# HISTORIC AND DESIGN REVIEW COMMISSION

**HDRC CASE NO:** 2021-592  
**ADDRESS:** 703 MISSION RD  
**LEGAL DESCRIPTION:** NCB 6917 BLK 0 LOT 18, 19, N IRR 98.13 FT OF 10, W IRR 110 FT OF 20, 21, 22, & E IRR 50 FT OF 23 & P-100  
**ZONING:** C-3, H, MPOD-1, RIO-4  
**CITY COUNCIL DIST.:** 3  
**DISTRICT:** Mission Historic District  
**APPLICANT:** FT Builder Services, LLc.  
**OWNER:** NIZAR VENTURES LLC  
**TYPE OF WORK:** Construction of a gas station, contributing status review  
**APPLICATION RECEIVED:** November 15, 2021  
**60-DAY REVIEW:** Not applicable due to City Council Emergency Orders  
**CASE MANAGER:** Edward Hall

## REQUEST:

The applicant is requesting a Certificate of Appropriateness for approval to construct a commercial structure at 703 Mission Road, located within the Mission Historic District and Mission Protection Overlay District 1. The existing structure and canopy located on the property is proposed for demolition.

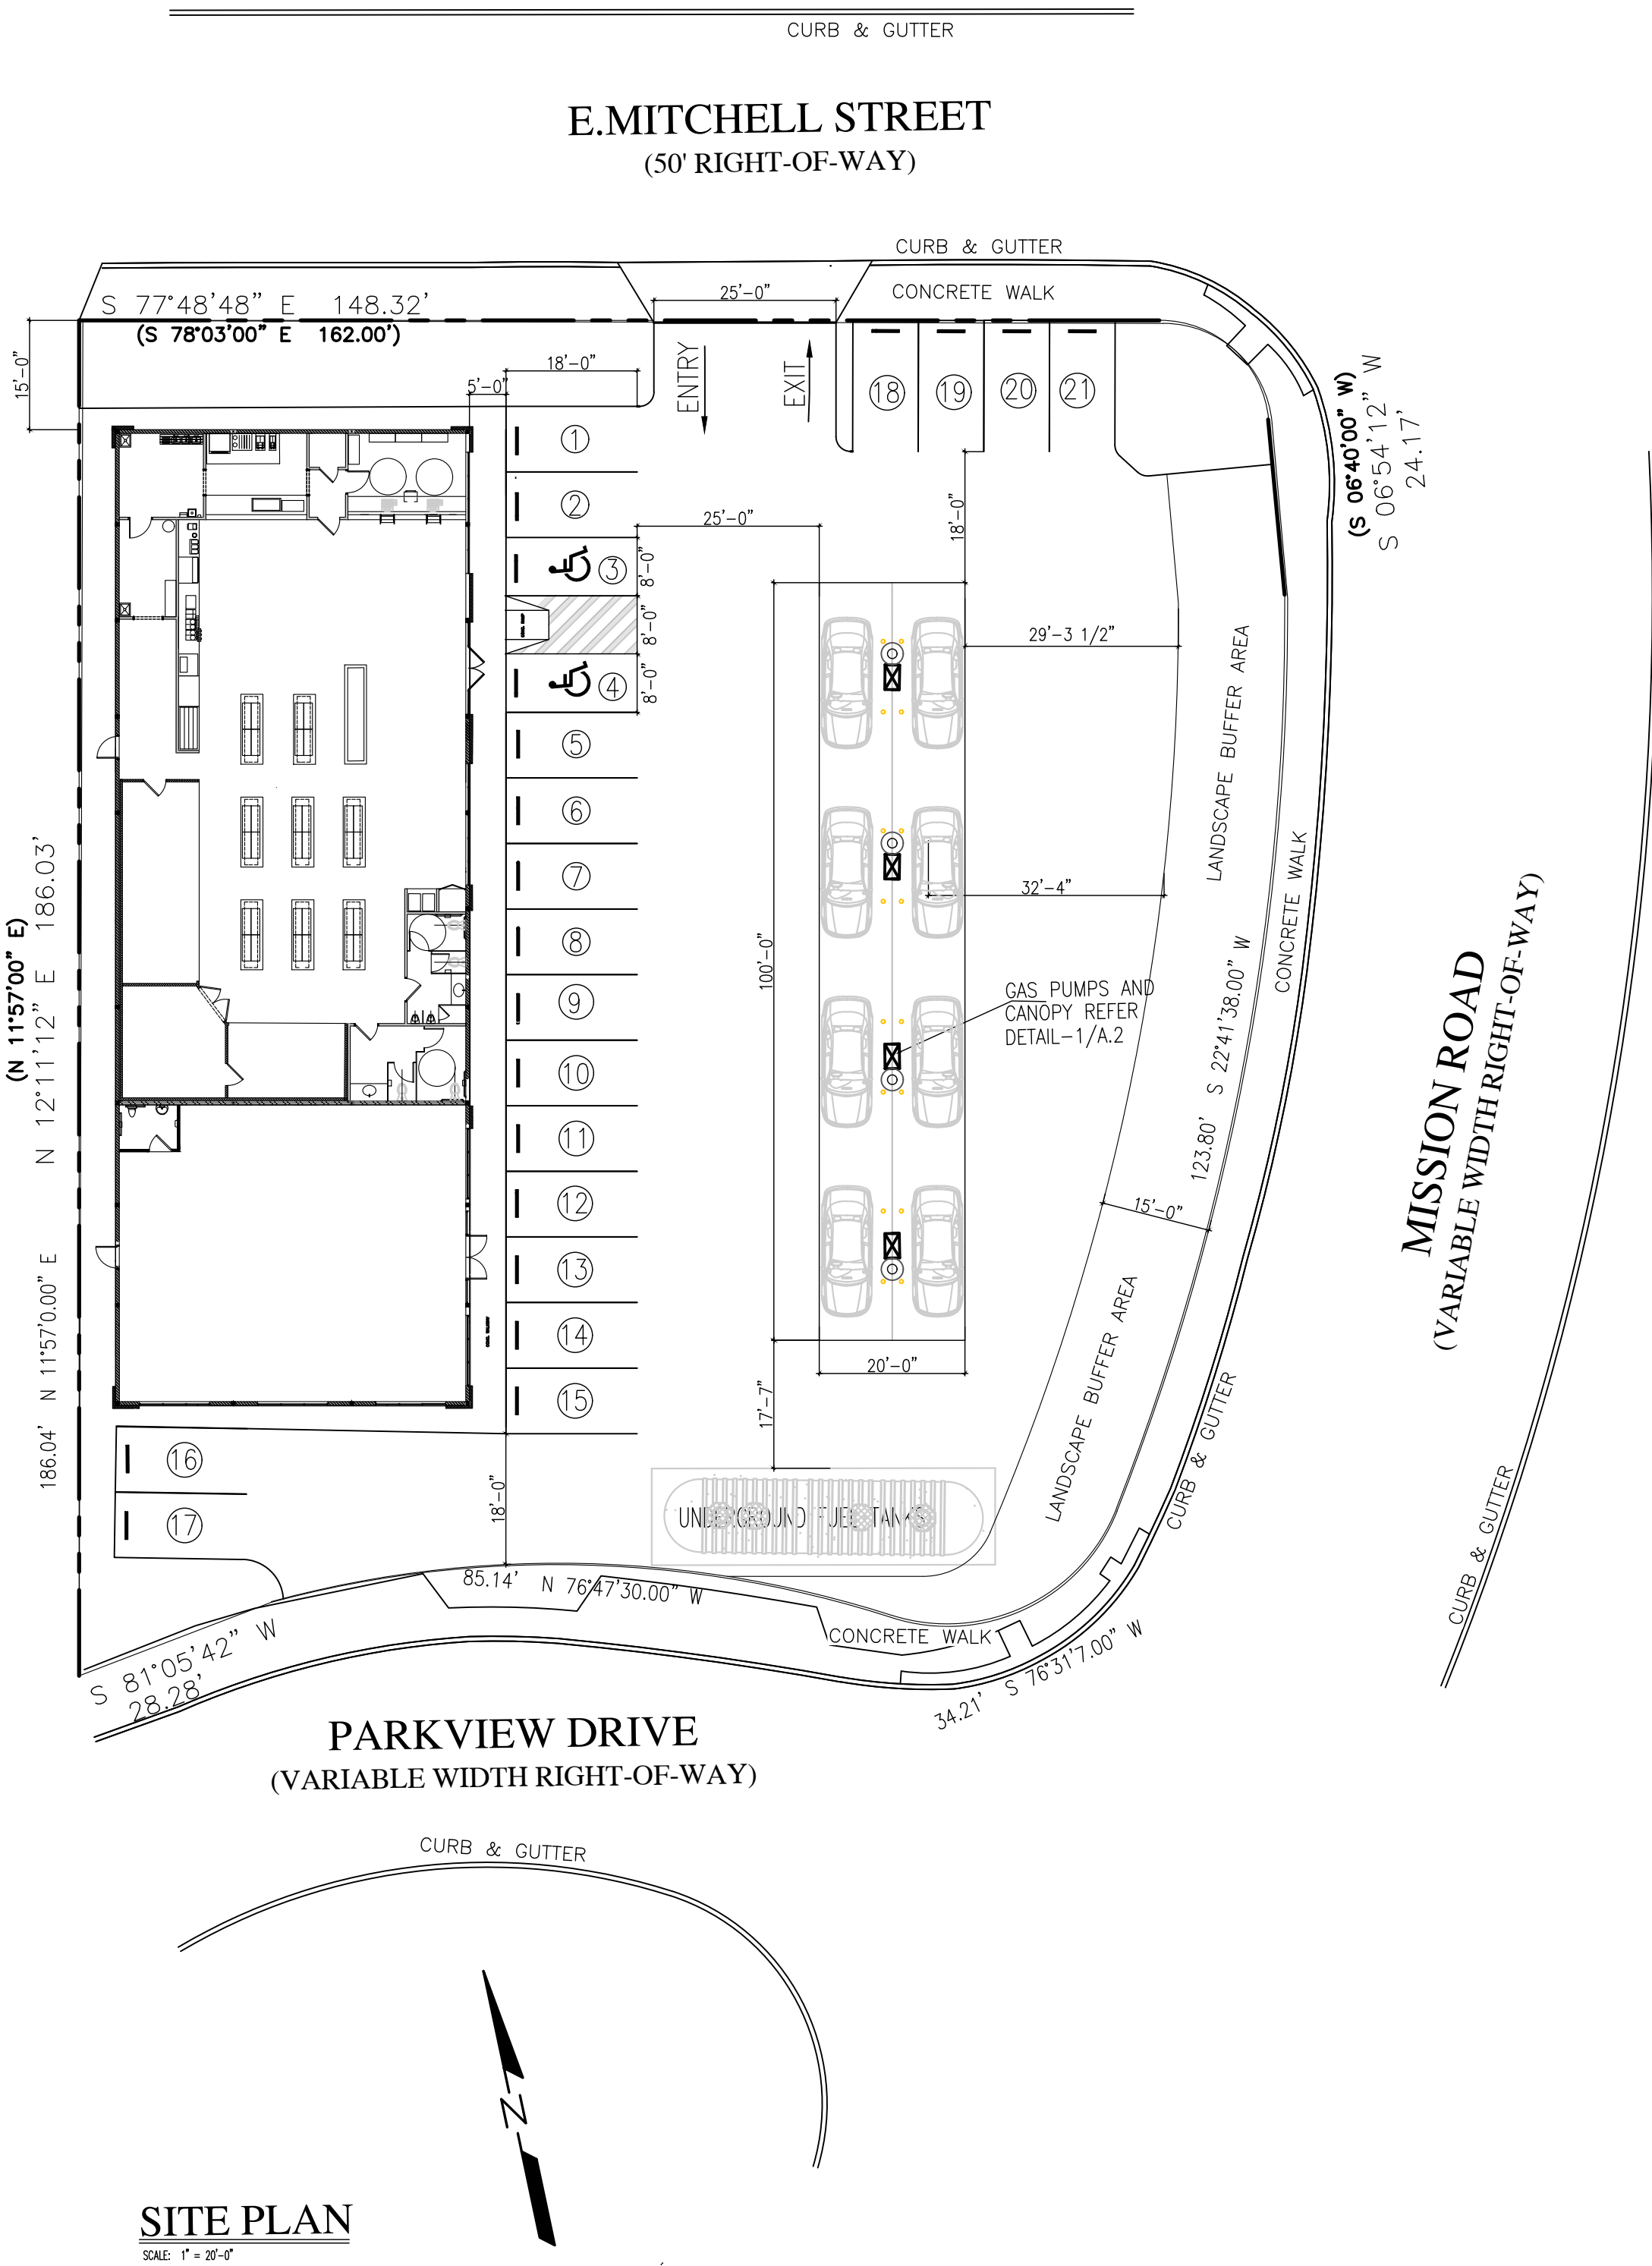
- p. **LANDSCAPING** – At this time the applicant has not provided information regarding landscaping. As noted in finding h, landscaping buffers are required per both the Mission Historic District Design Manual and the UDC's River Improvement Overlay standards. Staff finds that a detailed landscaping plan that is consistent with both the Mission Historic District Design Manual and the UDC should be submitted to OHP staff for review and approval.

- t. **DUMPSTER LOCATIONS** – The applicant has not noted the specific, designed location of on site dumpsters. Staff finds that the proposed location for dumpster storage should be noted on the site plan for review.

MS, JC: General discussion on the site plan. Landscaping elements should be added.

Concerns regarding the impact on traffic and pedestrian access around and across the site.

- i. That the applicant present options that preserve, relocate, or recreate the mural on site.
- ii. That the applicant proposes parking and site design that is consistent with the landscaping, parking and site design requirements outlined in the UDC Section 35-672 and the Mission Historic District Design Manual, as noted in finding h.
- iii. That the applicant submits a robust landscaping plan that is consistent with the UDC Section 35-672 and the Mission Historic District Design Manual, as noted in finding p.
- iv. That the applicant provides a designed dumpster location on site for review and approval, as noted in finding t.

**FRONT ELEVATION**  
SCALE : 3/16" = 1'-0"

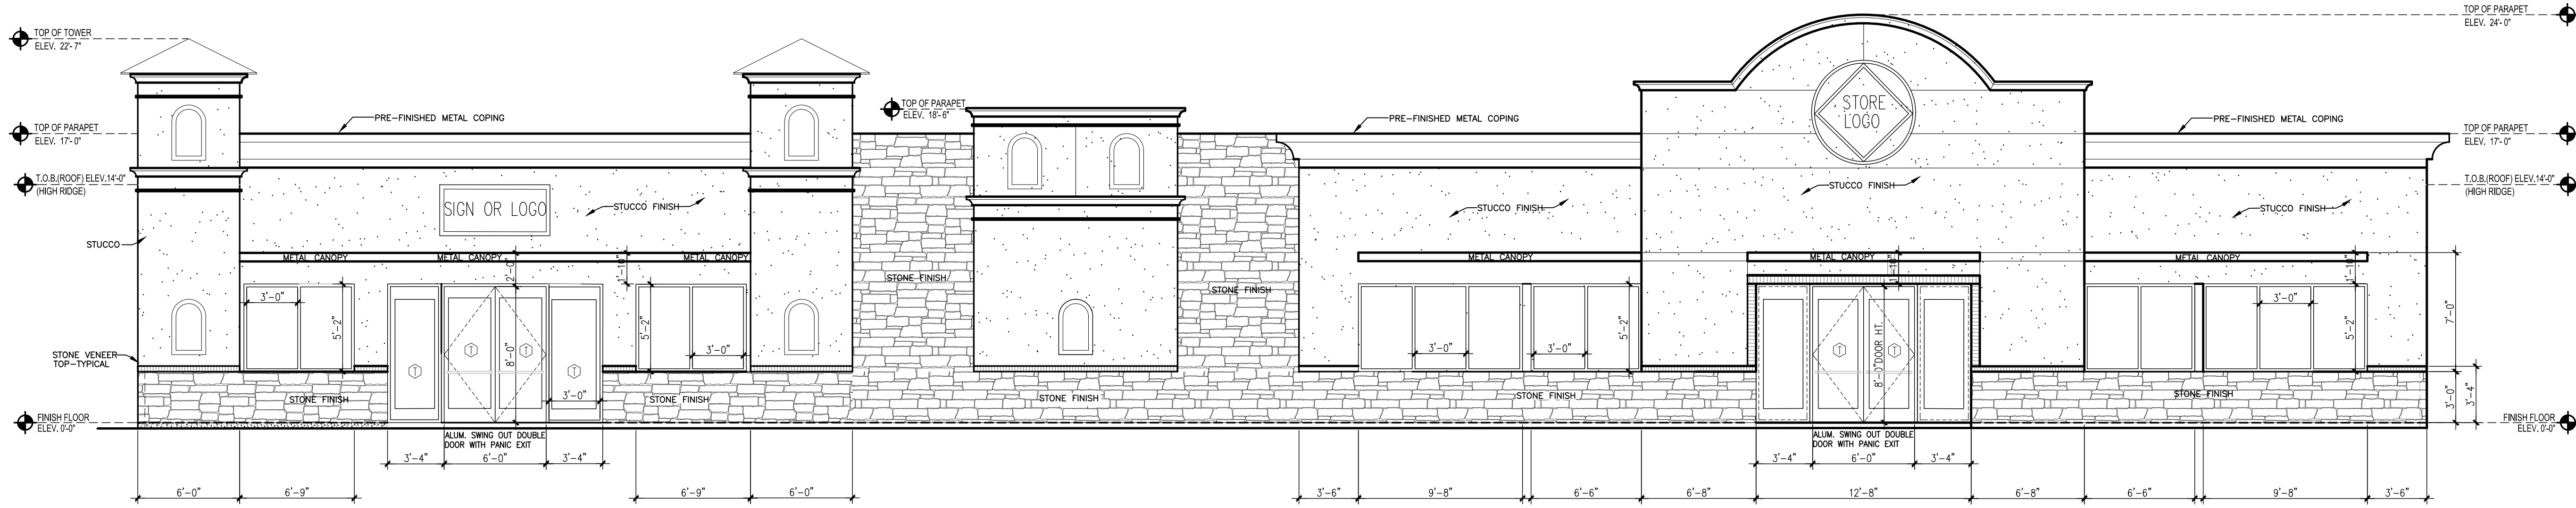
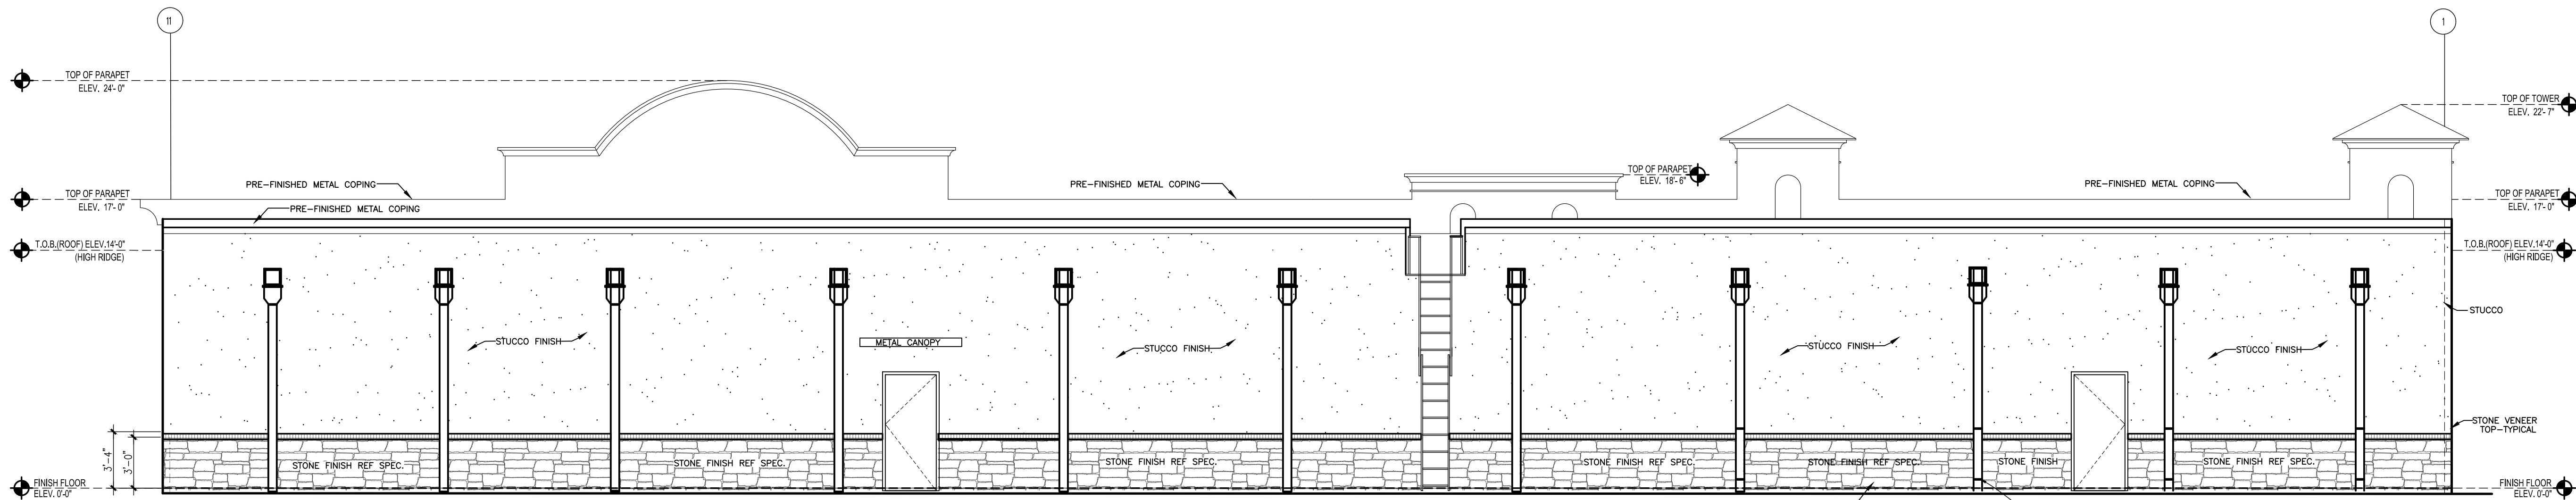
- k. **NEW CONSTRUCTION (Mass, Scale, and Form)** – The Mission Historic District Design Manual 2.B. notes that wall planes and fenestration should be organized to yield facades that appear monolithic and enduring while still allowing for visual interest through breaks in scale and pattern, facades should not exceed more than fifty (50) feet in length uninterrupted, and heights should not exceed more than 3 stories in height. The applicant has proposed for two facades, one of 133' and the other of 48' to be uninterrupted with no changed in massing, fenestration or façade arrangement. Staff finds this to be inconsistent with the Mission Historic District Design Manual.

- v. That the applicant introduces elements that separate blank facades, such as changes in materials, wall planes or fenestration, as noted in finding k.
